SUBJECT: SAFETY RECALL NOTIFICATION

DATE : OCTOBER 2006 SECTION : 12
 SUBJECT : BENDIX® SR-7™ SPRING BRAKE MODULATING VALVE

Sr06-10

Bendix® SR-7™ Valve Recall Campaign Identification Guidelines

FIGURE1: SR-7 VALVE

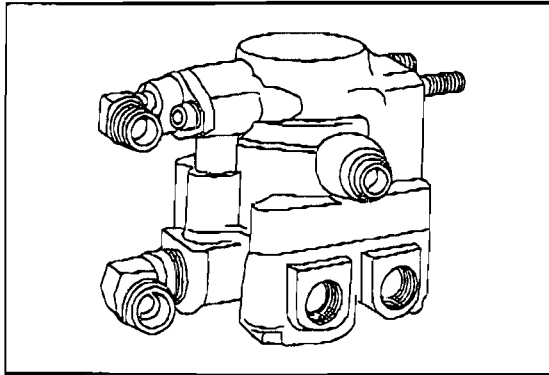
Bendix has determined that a check valve inside the Bendix® SR-7™ spring brake modulating valve may not properly seat, causing internal valve leakage. The leakage can result in delayed application of the spring brakes to park the vehicle upon pulling of the dash valve button. The delay, which could last up to three minutes, may be accompanied by secondary air leakage, such that the secondary reservoir is depleted. During this time, there is a risk that the vehicle can roll away. This issue does not affect the operation of the vehicles service brakes, however it could affect the emergency stopping distance in the event of a primary air system failure application of parking brakes.

3. Remove the L.H. side hinged rear fender or raise the vehicle to access the spring brake valve.
4. Identify all lines before disconnecting then disconnect the lines and hoses from the spring brake valve.
5. Remove the two mounting nuts that secure the valve to the frame rail then remove the valve.

1. Align the mounting studs with the mounting holes on the vehicle frame rail. Tighten the mounting nuts to 180-220 inch-lbs.
2. Install the valve (642015) onto the vehicle ensuring all ports are connected as marked during disassembly.

FIGURE 2: AIR-OPERATED BRAKING SYSTEM H3

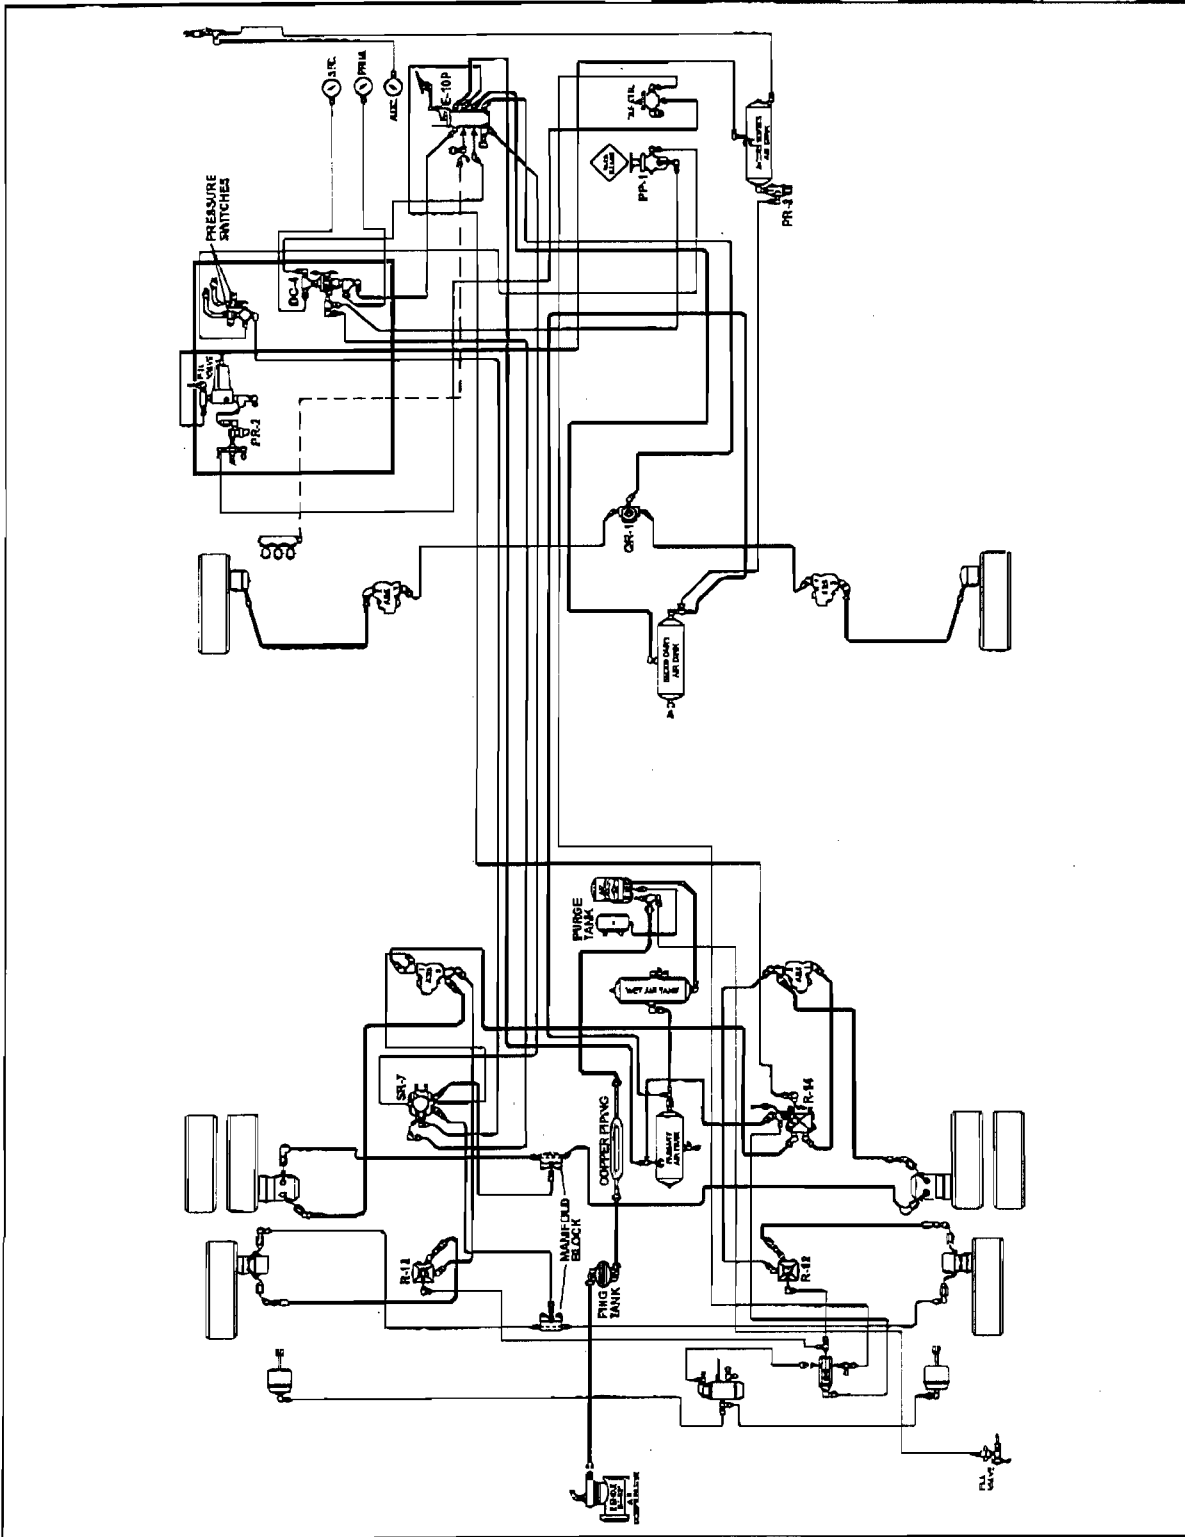
1. Drain all vehicle reservoirs.
2. The spring brake valve is located above the drive axle, behind the L.H. side hinged rear fender (Refer to figure 2 for H3 vehicles) or in the rear underframe (Refer to figures 3 & 4 for X3-45 coaches).

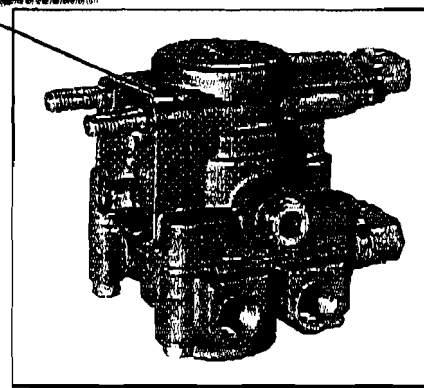
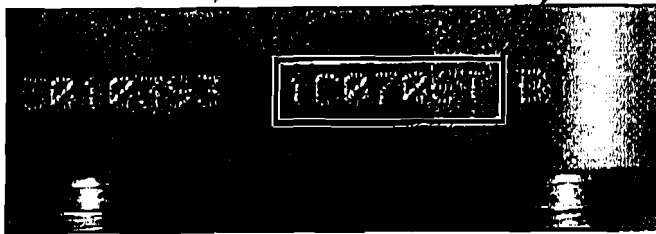
Step 1: Identify the casting as either Bendix 1 or Bendix 2.
(Located on the side of the valve as shown.)

If the casting has "Bendix 1" on the side, it is potentially affected by the recall campaign and must be further identified.

If the casting has "Bendix 2" on the side, it is not affected by the recall campaign, and no further action is required.

Date Code Location

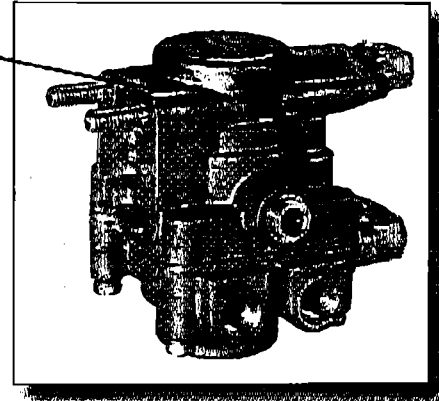
Step 2: Identify the date of manufacture.
(Date code located on the top of the valve as shown.)

SR-7™ valves with the casting code "Bendix 1" manufactured between April 1, 2006 and May 24, 2006 are subject to the recall campaign and must be replaced.

SR-7™ valves with a casting code "Bendix 1" and the following date codes are subject to the recall campaign and must be replaced per the SR-7™ Recall Campaign Guidelines.

D0106 (April 1, 2006) through _E2406_ (May 24, 2006) inclusive.
